Impact of Singapore Land Reclamations

Report of the Group of Independent Experts (GOE)

ITLOS Order of 8 October, 2003

5 November 2004

Figure 5 Pulau Tekong with Sheetpile Silt Curtain around Area D (PT Case 1)
[Derived from the DHI Reports]

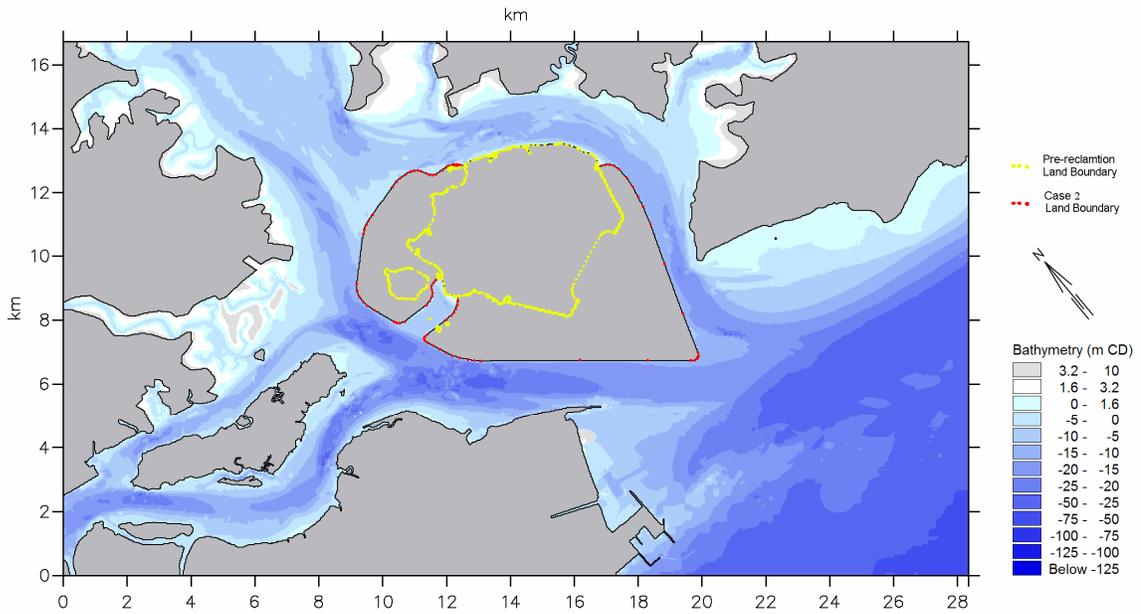
To pass the same amount of water through a narrower channel requires increased current velocities. The increased current velocities in Kuala Johor and Calder Harbour are therefore mainly a direct result of the decreases in the cross-sectional area of the channels in the vicinity of the Pulau Tekong reclamation, particularly near Area D (shown in Figure 5).

Singapore, along Kuala Johor, indicated in Figure 5). These eddies result in increased current velocities across the channel, which affect navigation through the area. Although the impacts of these eddies on navigation were not found to cause unsafe conditions in the short term due to the low traffic density in the channel and the compulsory presence of pilots on board of vessels transiting this fairway, the GOE is nevertheless of the opinion that a reduction in the strength or complete elimination of the eddies will increase the safety of passage of vessels through this channel.

Figure 1.1 – Maximum Current Velocities at PULAREK Ebb (top), Flood (bottom)

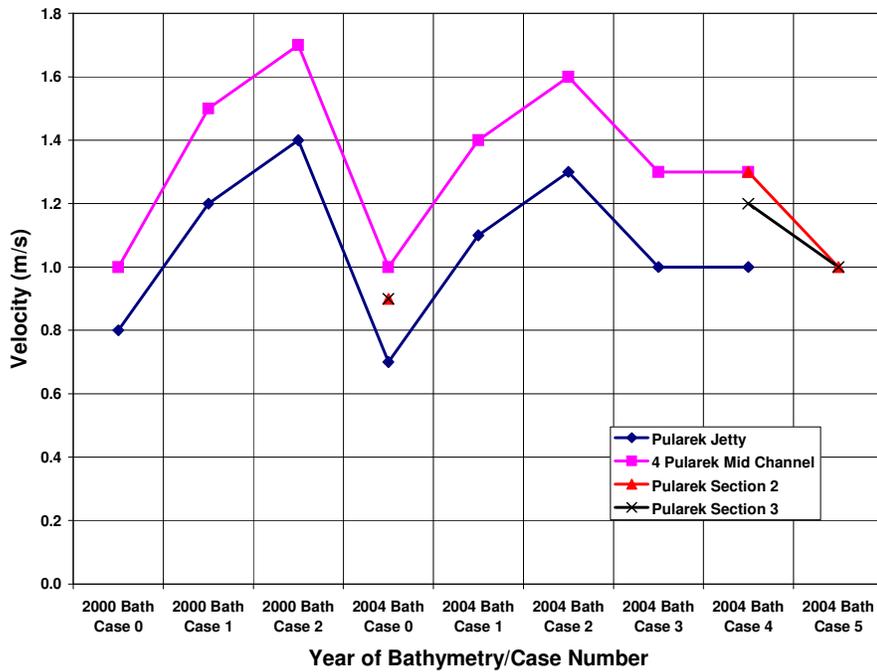
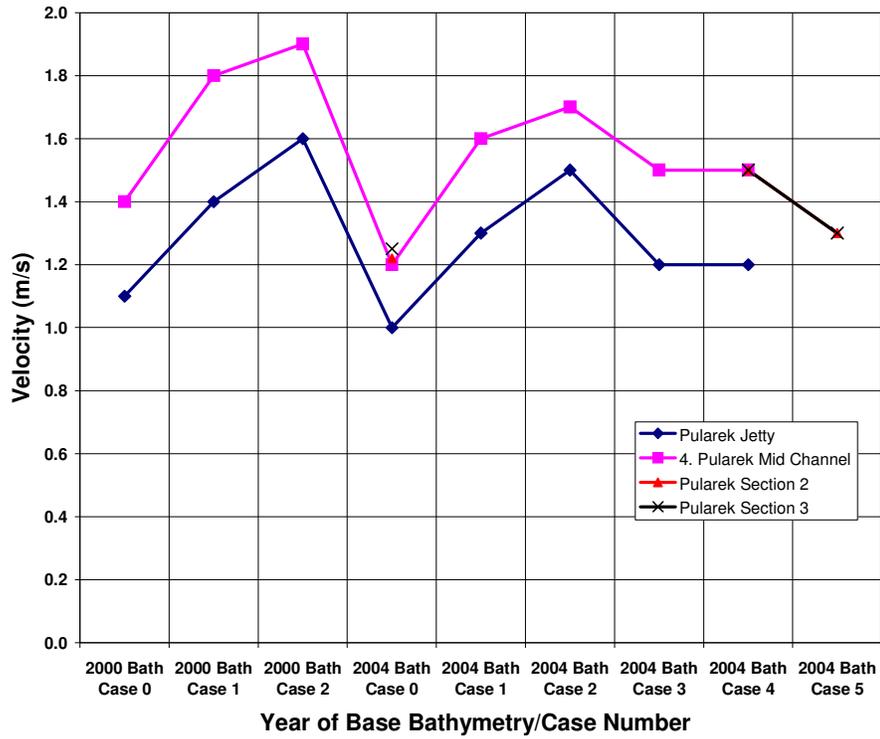
The studies indicate an increase in current velocities in the channel, both for ebb and flood conditions. The GOE has presented the data given by DHI in Table format in a more visual way in Figure 1-1 attached to this report.

Increase in channel conveyance (channel width) to reduce the current velocities.

Figure 1.2 – Maximum Current Velocities in Kuala Johor - Ebb (top), Flood (bottom)

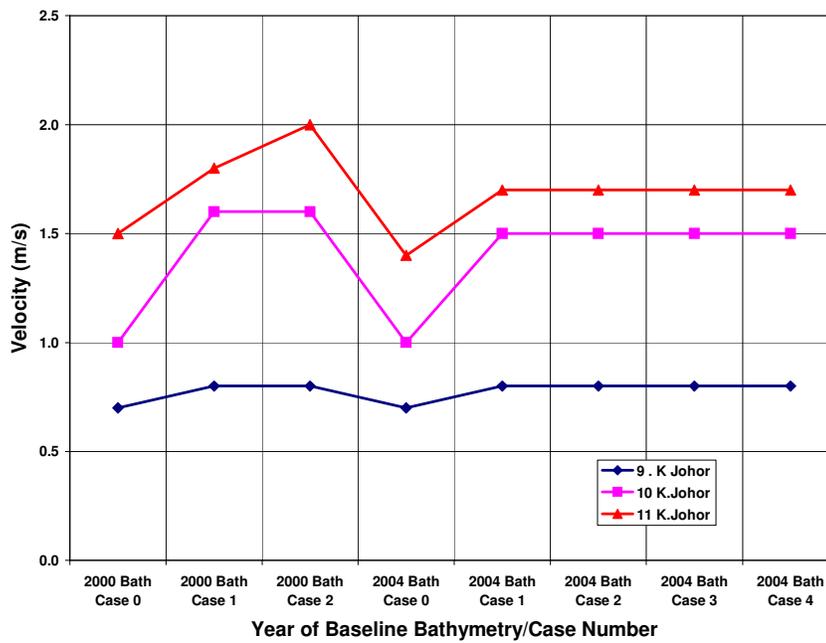
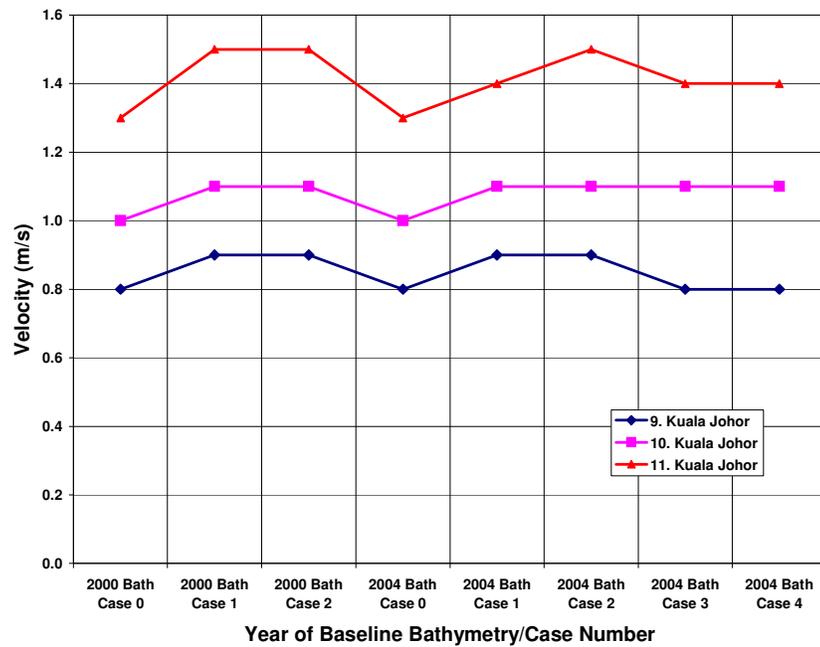
Velocities in the channel increase, see Figure 1-2. The duration of slack water will decrease. The eddy shedding from Changi finger at flood tide will become more pronounced and will persist during part of the ebb tide. Water levels are slightly lower, while the tidal amplitude remains unchanged. Case 2 leads to slightly higher velocities than Case 1.

As a measure against eddy shedding, streamlining the Changi finger will be effective, as indicated by the addendum report by DHI. Since the present configuration can be considered as a construction phase of the Changi reclamation, such a measure is recommended as a part of the ongoing works in the area.

Figure 1 - Sensitivity Test 1 (Case 3)

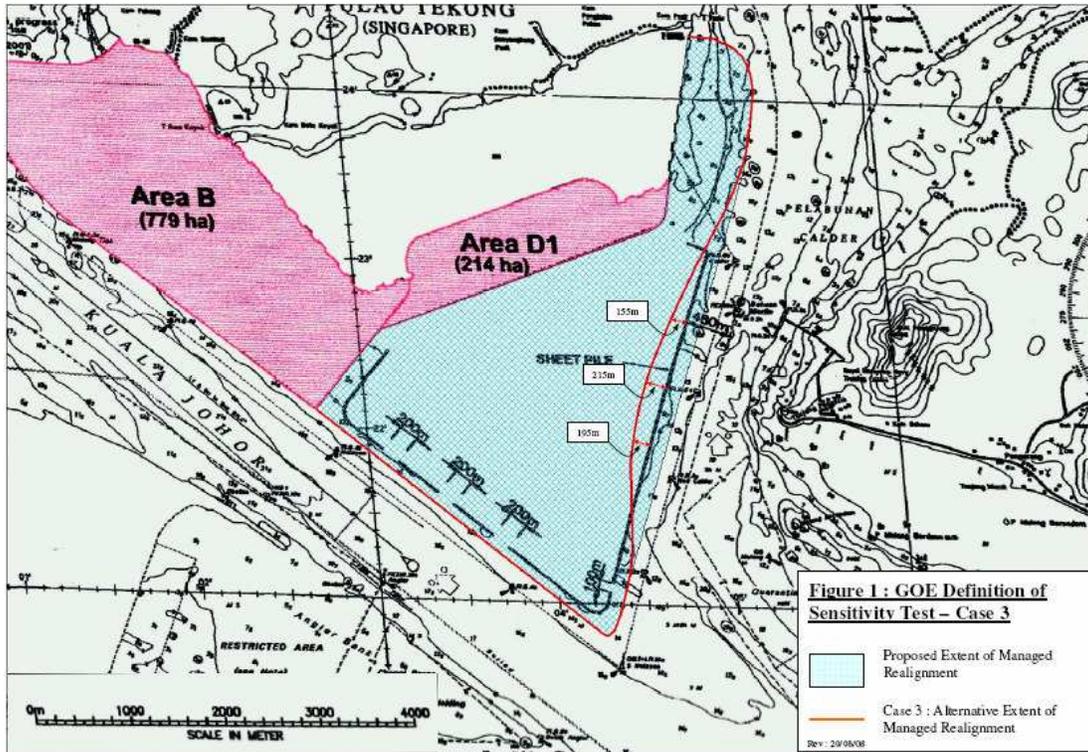
In order to understand the sensitivity of the hydrodynamic characteristics to a change in the shape of the eastern boundary of Area D, GOE proposes to streamline the Calder Harbour flow channel, as indicated in Figure 1.⁶ The change to the Area D geometry needs to be substantial in order to determine the sensitivity of the flow conditions around the whole island to such a change.

Figure 2 - Sensitivity Test 2 (Case 4)

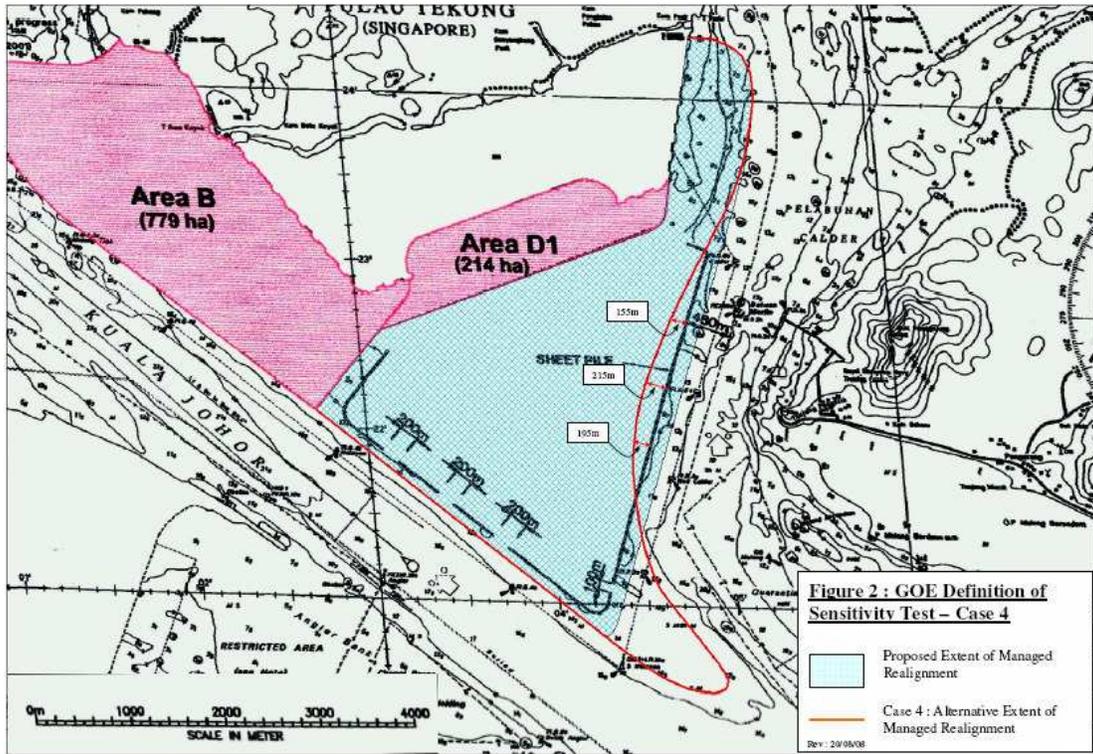
In order to understand the sensitivity of the hydrodynamic characteristics to a change in the shape of the southerly point of the reclamation, GOE proposes to add a tail to the reclamation in the southwesterly direction, as indicated in Figure 2 to direct the flow from and into the channels on either side of P. Tekong.
